STATE OF HAWAII DEPARTMENT OF TRANSPORTATION HIGHWAYS DIVISION

ADDENDUM NO. 3

KAMEHAMEHA V HIGHWAY, KAWELA BRIDGE REPLACEMENT DISTRICT OF MOLOKAI, ISLAND OF MOLOKAI FEDERAL-AID PROJECT NO. BR-0450(8)

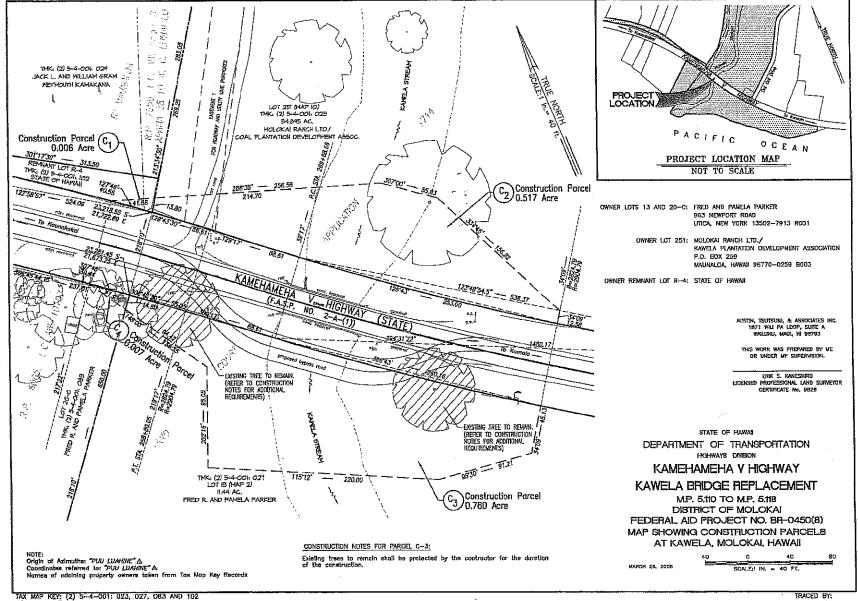
6. Will Section 503.03 (M)(3)(a)1. - Machine Finishing apply to the Kawela Bridge Deck? You can find the spec on page 503-25 of DOT Standard Specs.

Response: Finish bridge decks and approach slabs with concrete wearing surfaces in accordance with Subsection 503.03(M)(3)(a)1. – Machine Finishing. Manual Finishing may be used only for hand-operated float boards and transverse finishing, as specified Subsection 503.03(M)(3)(a)1. – Machine Finishing. The Manual Finishing shall not replace the use of Machine Finishing for strike off and finishing.
